Friends of Squibnocket

Squibnocket Committee
Town of Chilmark, MA 01742

Response to Haley & Aldrich Nov 14th Memorandum

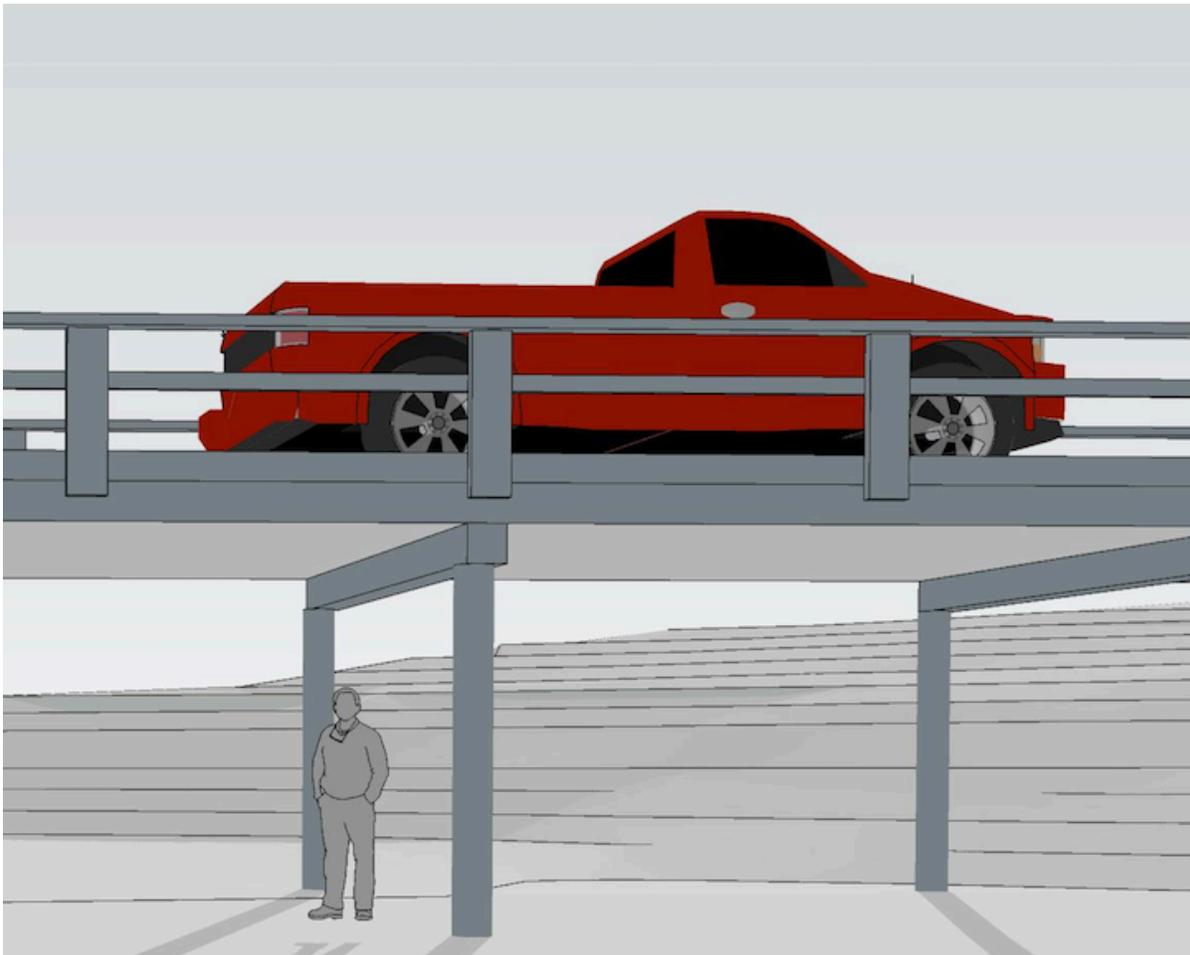
1. **The bridge will degrade the natural beauty of the beach area:** The bridge will be the dominant feature of the beach due to its overall height and proximity to the shoreline. We are providing the visual representation¹ below to show the scale of the bridge and to respond to H&A's comment that we had misrepresented the dimensions of the bridge. Based on H&A technical documentation, the bridge will be 19' above sea level, which translates to a 'real' elevation of 15' above the actual terrain for most of the bridge's span from Squibnocket Road to Money Hill. More specifically, the 6' tall man in the illustration is on terrain that is 4' above sea level (4' of elevation). The bottom of the bridge deck is 3' above his head; it is an additional 2' to top of road deck; plus another 4' to top of railing for a total of 19'. Truck cab extends visual effect another 2 1/2' above the railing. The total distance from ground level to the top of the truck roof is 17½'.
